***115 kV A1B 'A' Line Protection Upgrade at Aguasabon SS
Notification of Final Approval of Connection Proposal
CAA ID Number: 2009-EX454***

ASSESSMENT SUMMARY**Aguasabon SS****1.0 GENERAL DESCRIPTION**

Plot 1: A1B apparent impedance for L-L-G fault on M23L at Marathon with EWTE =325 MW, LFE = 398 MW

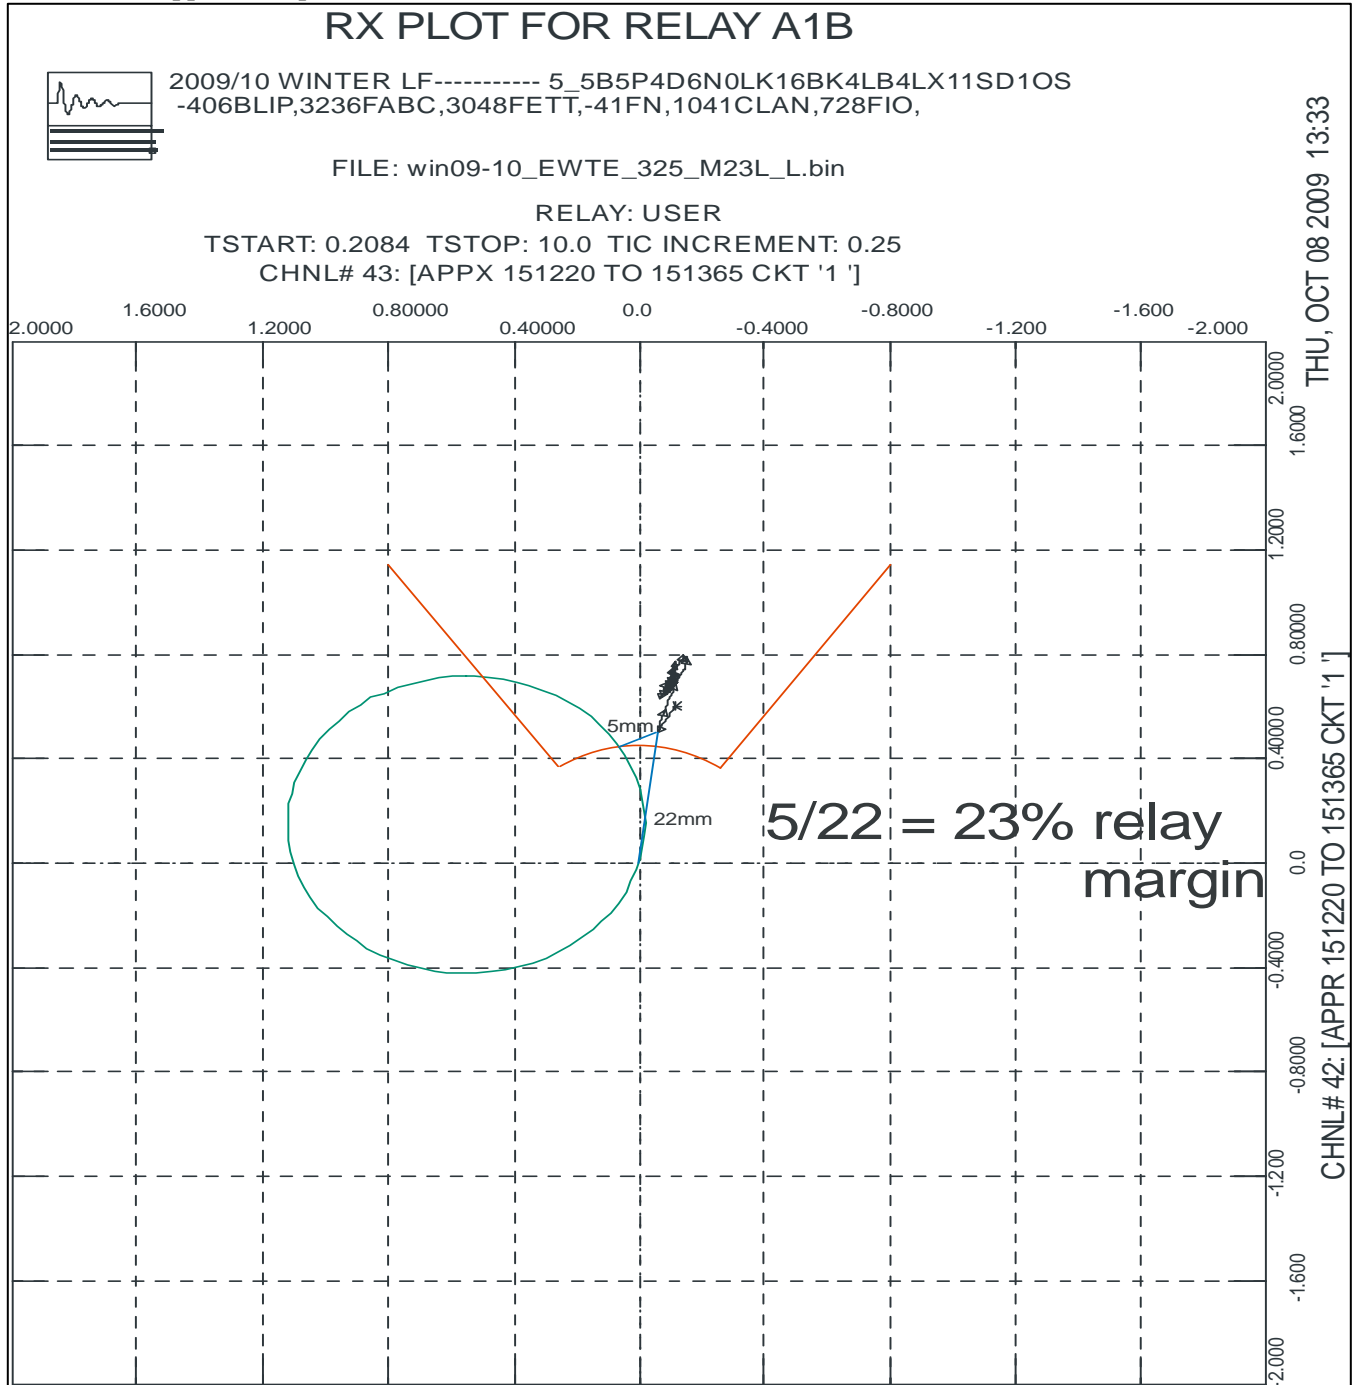
The lowest relay margin of 23% was found under scenario 1 for a phase-phase-ground fault on M23L at Marathon and the relay margin plot is shown below.

The IESO System Operations Manual 7.4, Appendix B, states that “Following fault clearance or the loss of an element without a fault, the margin on all instantaneous and timed distance relays that affect the integrity of the IESO-controlled grid, including generator loss of excitation and out-of-step relaying at major generating stations, must be at least 20 and 10 percent, respectively.”

The zone 3 protection on line A1B is a timed distance relay so the relay margin of 23% is greater than 10% and meets the above requirements.
